Inspection Report of 1005 Ruby Ave Vero Beach FL 32968
Prepared for Bob & Tracey Schafer

Inspection Report of 1005 Ruby Ave Vero Beach FL 32968

02.06.07

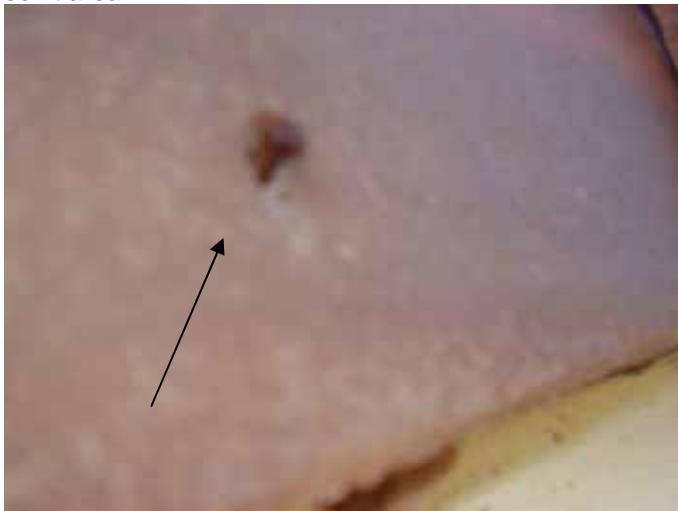
There was exposed lath at the soffit return above the front entry. There was not enough stucco applied to the soffit area.

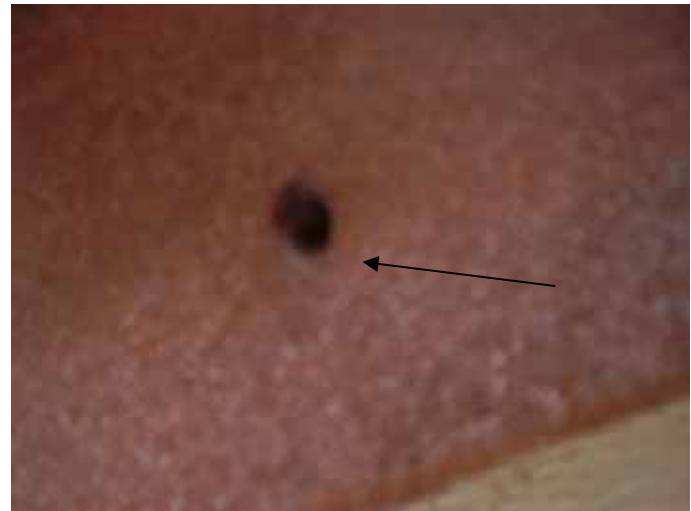
There were unsealed openings at the soffit return areas that can allow pest intrusion into the attic & house.

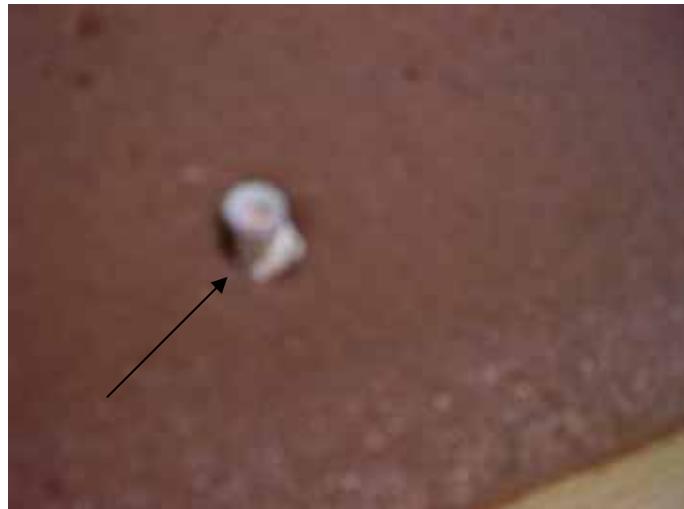
There was rust &/or corrosion at some of the rake tile anchor nails. §1506.5 Fasteners

Some of the rake tile anchor nails were loose or not correctly secured. – Hazard.

All of the rake tile anchor nails should be made of corrosion resistant material as per FBC §1506.5 Fasteners & R118-2.01A.

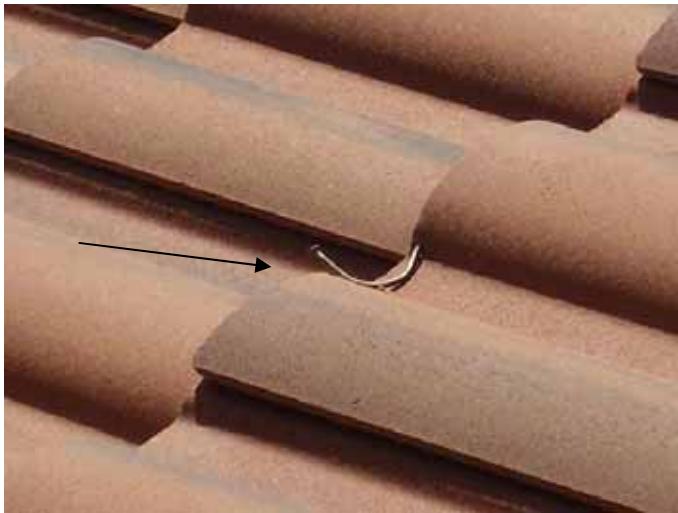
All nails & construction debris should be removed from the roof.

All nails & construction debris should be removed from the roof.

All nails & construction debris should be removed from the roof. – Hazard.

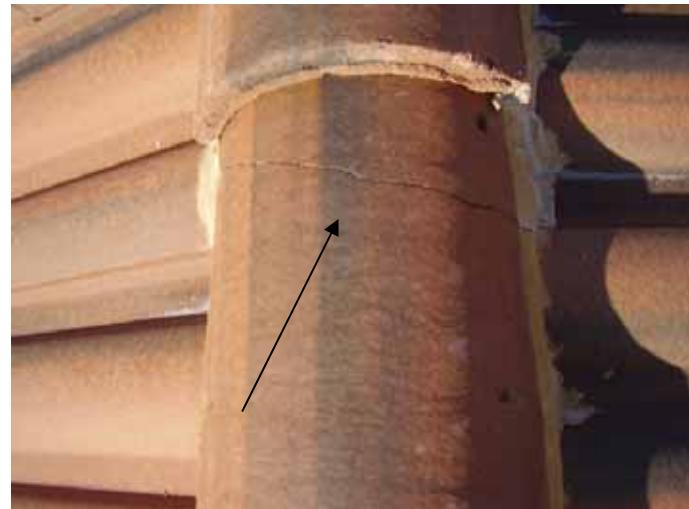
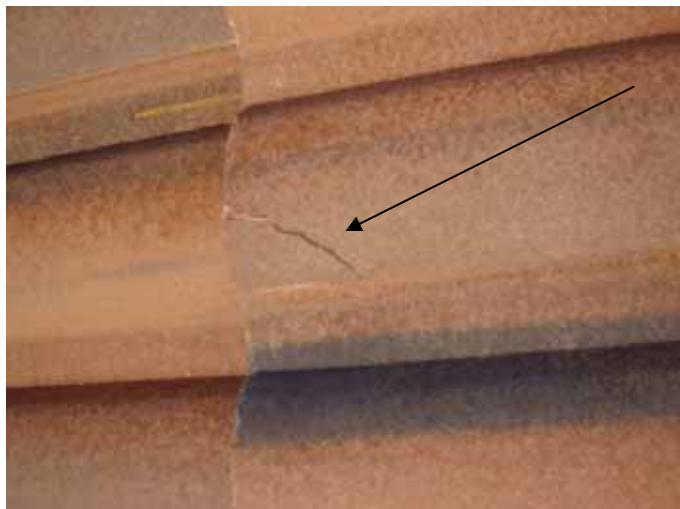
Some of the waste drain plumbing vent stacks are very close to the exhaust hood openings.

Some of the waste drain plumbing vent stacks are very close to the exhaust hood openings. Ref: §M401.5.1, §P904.5

The plumbing vent stack was not the correct height. The vent stack should terminate at 6 inches minimum above the roof. §P904.1

The opening can act as a make up air intake when the AC or Heat is running. Sewer gasses can be drawn back into the attic & house. §M401.5.1, §P904.5. We recommend installing dampers at the exhaust hoods to prevent any possibility of waste gasses re-entering the building.

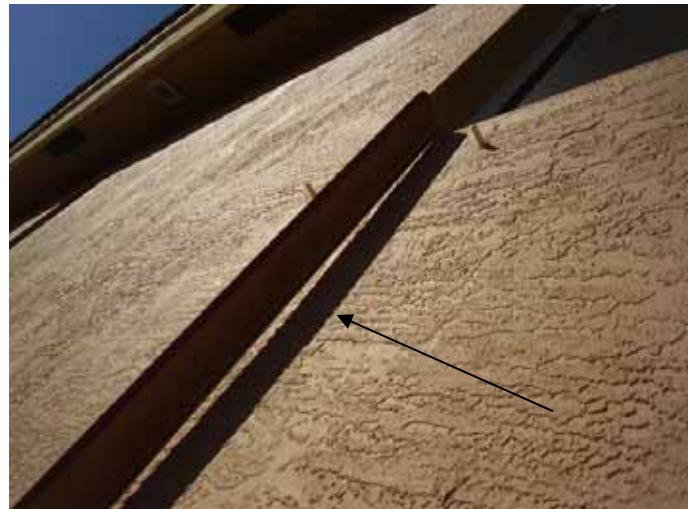
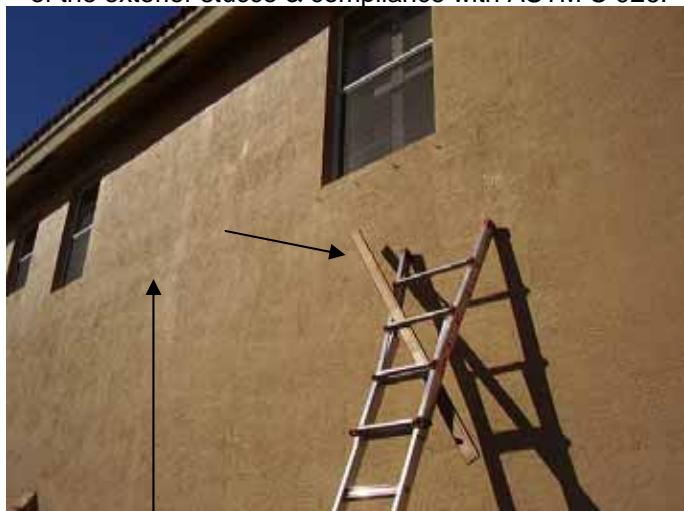
Some of the stucco work appears to be uneven & not the proper depth. ASTM C 926, §2504.2 §1403.1.3

The stucco at the some of the exterior walls is concave or curved in & does not appear to be the correct thickness. \$2504.2

Location of the previous photo/s. We recommend core sampling at the areas identified to verify the thickness of the exterior stucco & compliance with ASTM C 926.

We recommend core sampling at the areas identified to verify the thickness of the exterior stucco & compliance with ASTM C 926.

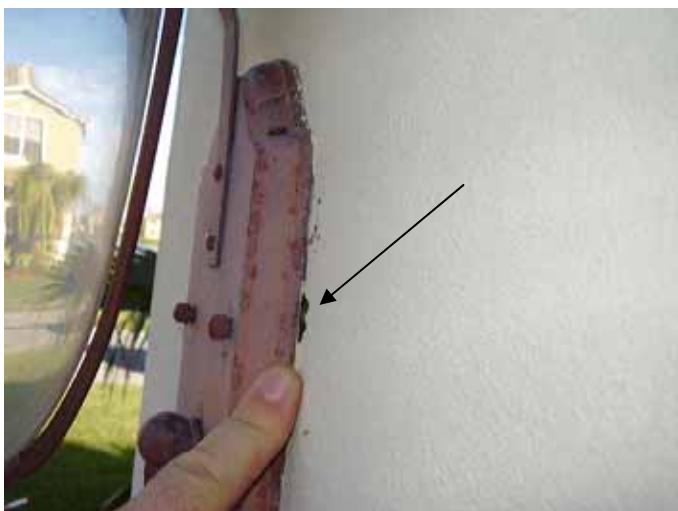
There were unsealed cracks in the stucco in the exterior wall under the NE side guest bedroom area window.

All of the cracks should be correctly sealed to prevent water & pest intrusion.

The area should be monitored for signs of additional cracking &/or settlement.

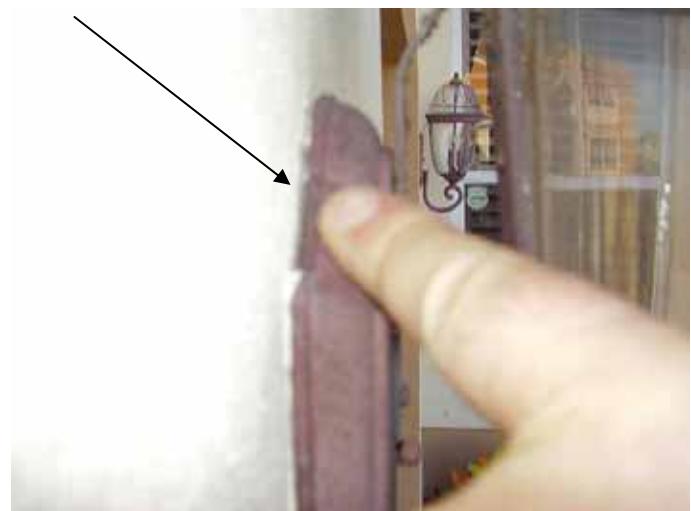
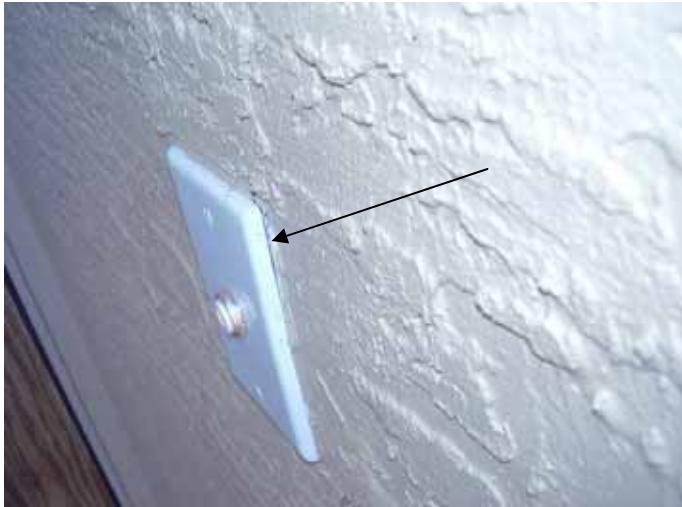
The exterior lighting fixtures were not completely sealed to prevent water & pest intrusion at the wall or base.
2002 NEC 410.4, §13-606.1.ABC.1.2

The doorbell cover was not completely sealed to prevent water & pest intrusion at the wall. 2002 NEC 410.4, §13-606.1.ABC.1.2

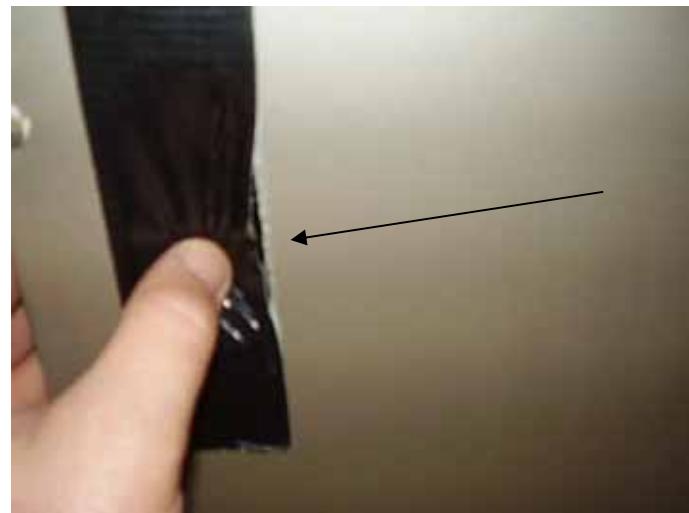
The grommet or seal is not installed around the low voltage line.

The AC mechanical closet was not completely sealed as required. §M603.1.3, §13-410.1.ABCD.3.7

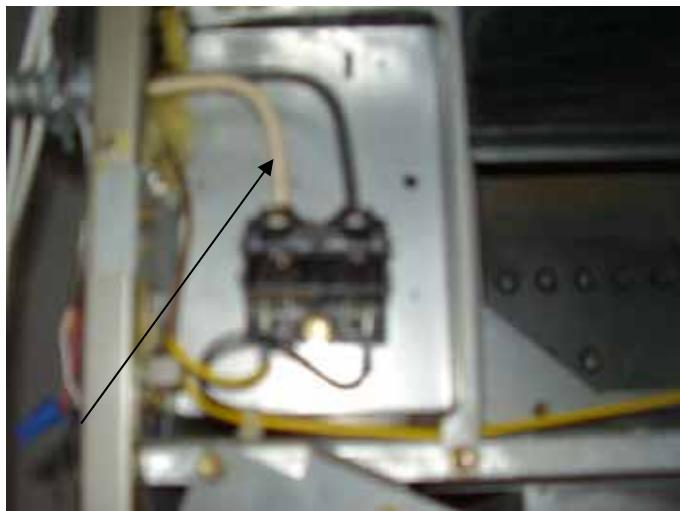
The tape patch was not correctly sealed at the opening in the front of AHU #1. The grommet provided by the AC manufacturer should be installed.

The white insulated wiring needs to be permanently marked or color coded to indicate it is being used as an ungrounded or "hot" conductor at the 240 volt circuitry.

The grommet provided by the AC manufacturer should be installed.

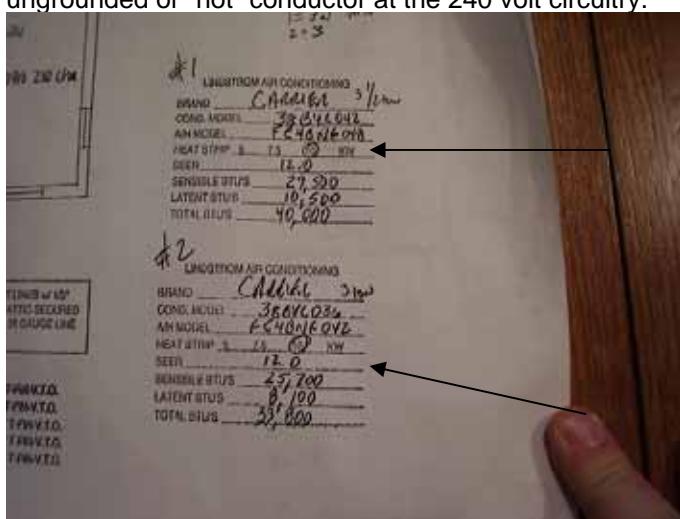
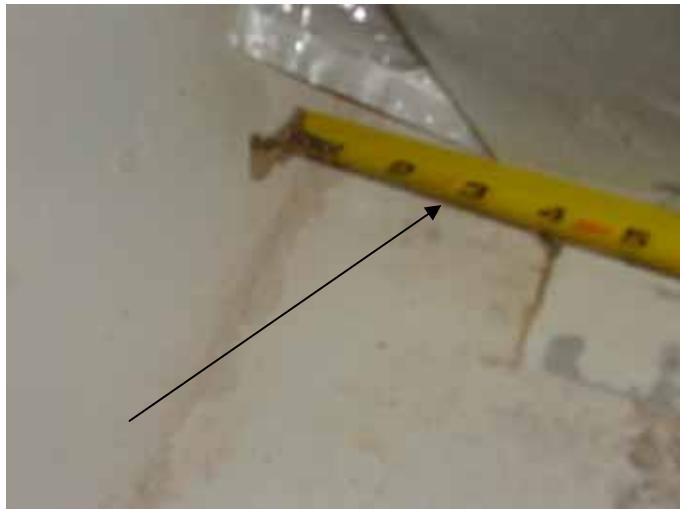
There were no electric heat strips located inside the furnace.

The mechanical plans call for a separate electric heat strips to be installed in the furnaces or handlers.

There was not sufficient clearance from the back of the wall to the AC air handler. §M603.1.3 4 inches of clearance is required.

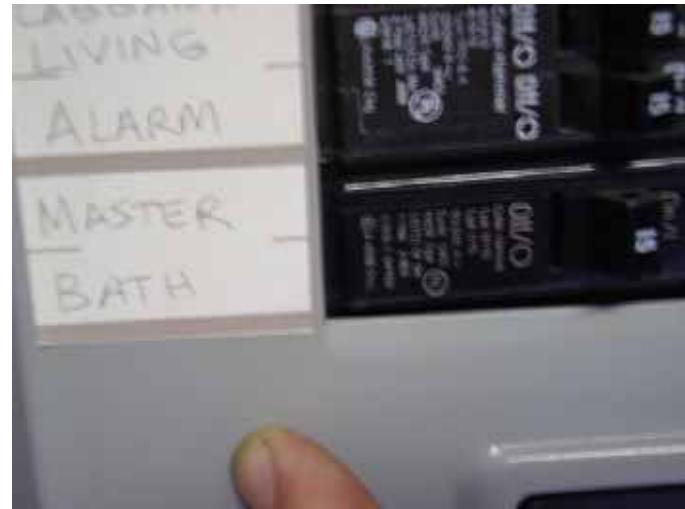
There were only 15 amp breakers at the furnace circuits in the main panel in the garage.

The approved plans called for 10kW w/ 60 amp or 7.5 kW with 40 amp overcurrent protection.

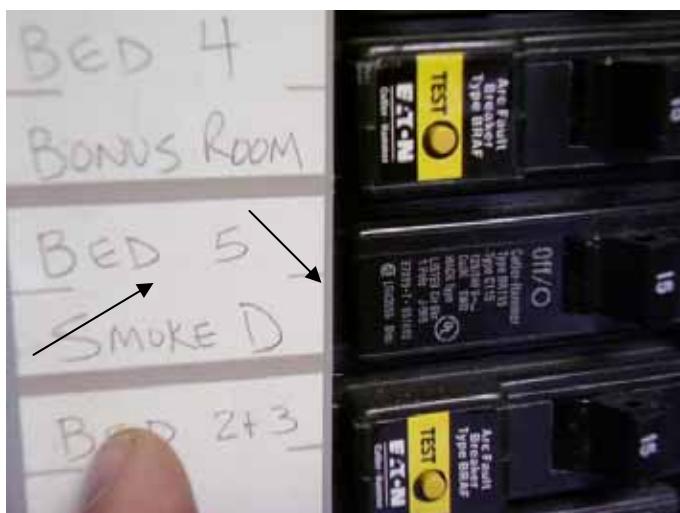
The bottom left circuit marked master bathroom was also used for several outlets in the master bedroom. AFCI protection should be provided at this circuit.
2002 NEC

There was no AFCI protection for the circuit marked BED 5 Smoke D.

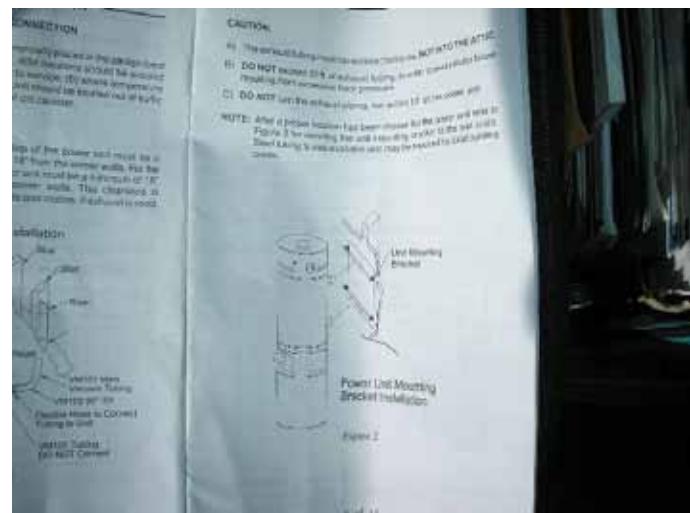
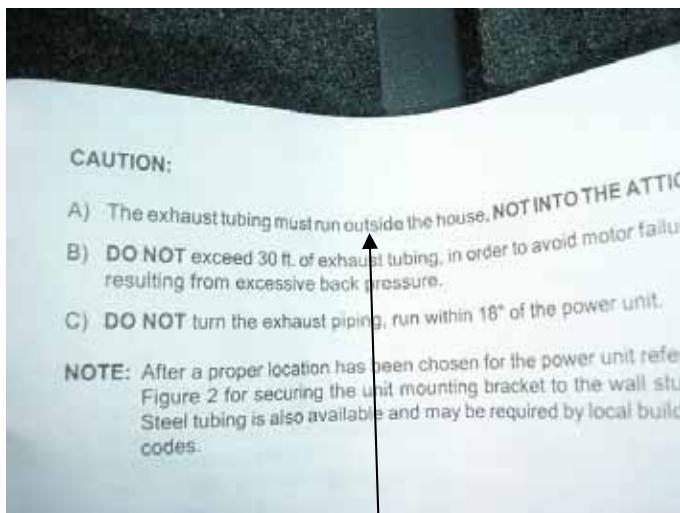
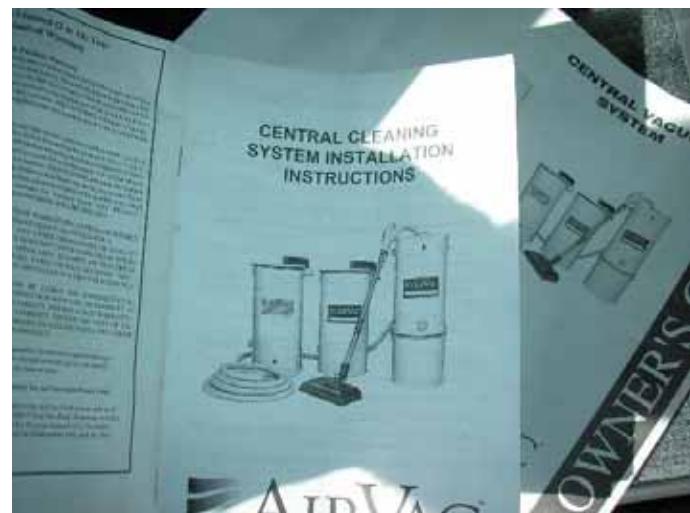
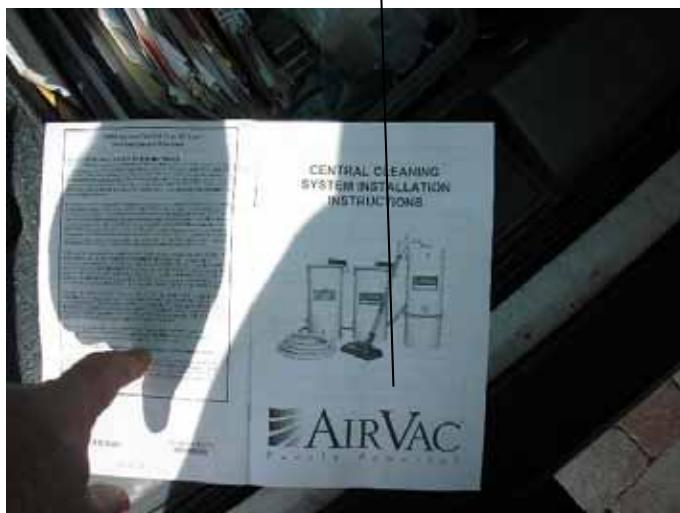
The central vacuum should be vented to the outdoors as per §M501.3 & by the manufacturer's installation instructions. See Below. §M304.1

The instructions state the exhaust tubing must be run outside of the house & not into the attic.

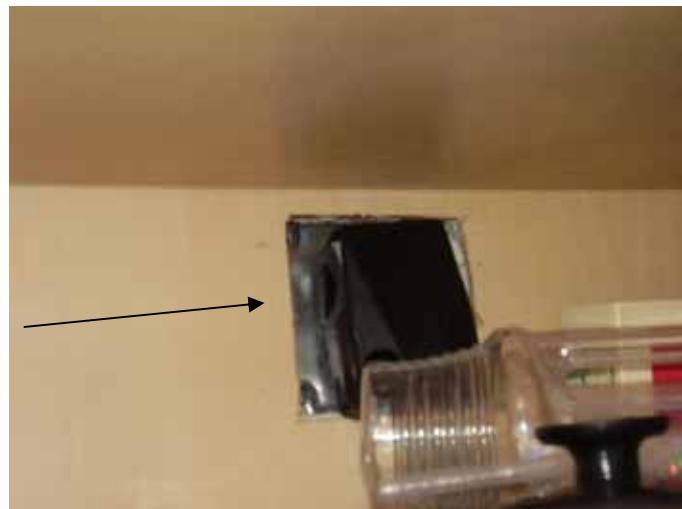
The top of the garage/laundry room access door frame was not correctly sealed. §13-606.1.ABC.1.2

Both sides of the door frame should be sealed.

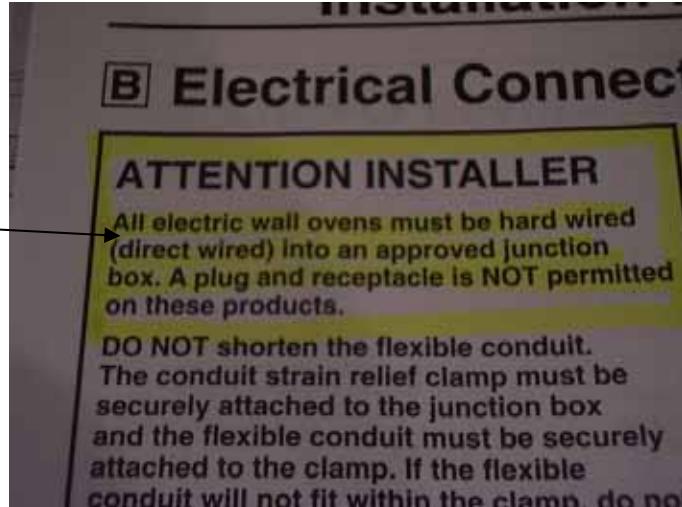
A plug & receptacle are not permitted for the wall oven electric supply. §M304.1

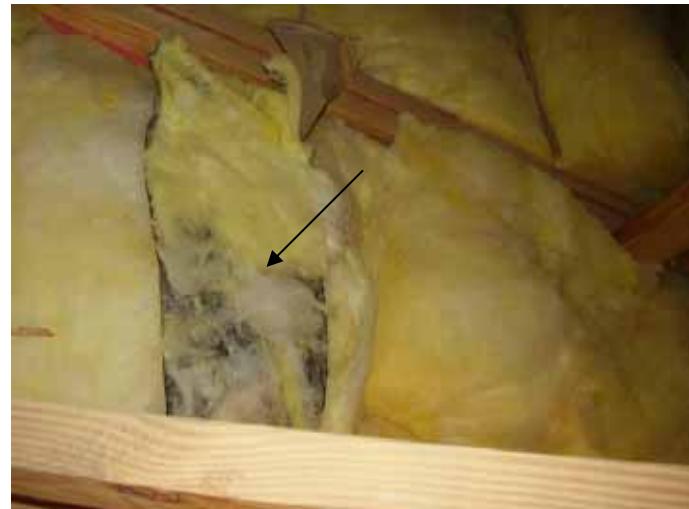
There was no insulation for the attic hatch cover. Insulation should be attached to the back of the attic access hatch cover.

The AC refrigerant ductwork was installed over the attic opening & obstructs entrance to the attic.

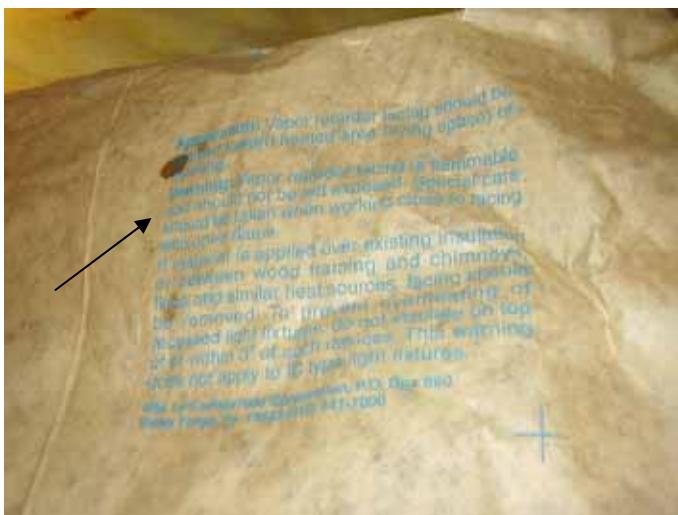
All insulation scraps & debris should be removed from the attic.

All insulation scraps & debris should be removed from the attic.

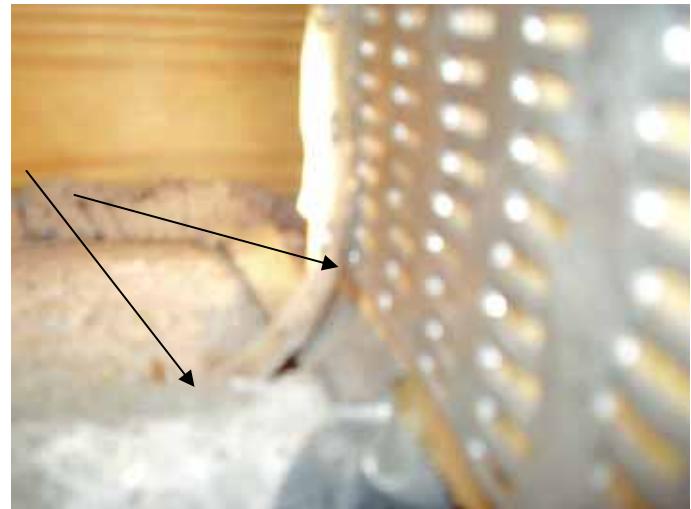
Location of the previous photo. There was no strap at this 2x6 roof framing component above the front gable end wall at the 2nd floor.

The 2x4 ceiling joist support was cut for the recessed lighting fixture & should be re-routed above the front entryway.

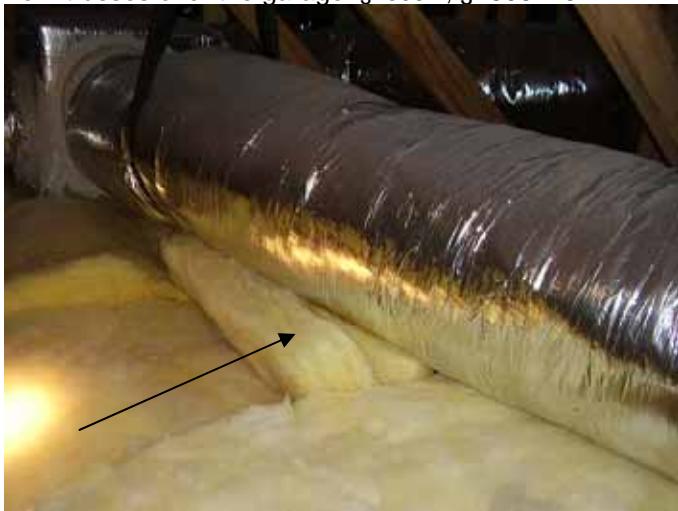
Some of the truss anchor straps are not correctly embedded in the concrete. They are offset 1& ½" or more from trusses over the garage. §2306.2, §1606.1.3

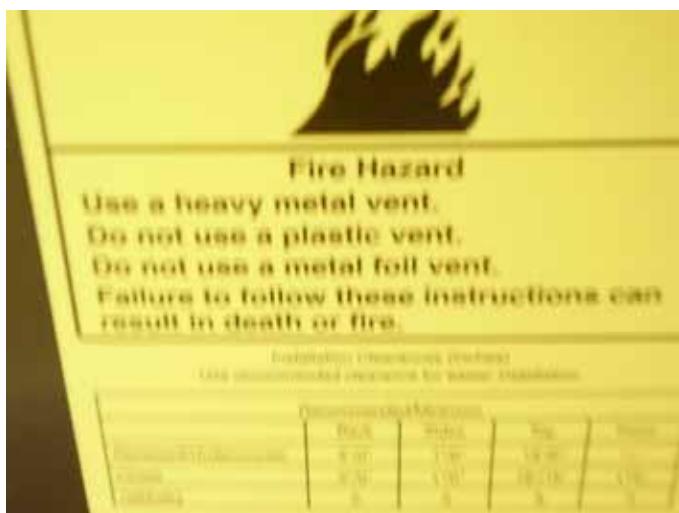
The grommet was not installed to secure the electrical wiring at the back of the dryer. – Shock Hazard.

The foil vent is not permitted for use with this dryer.
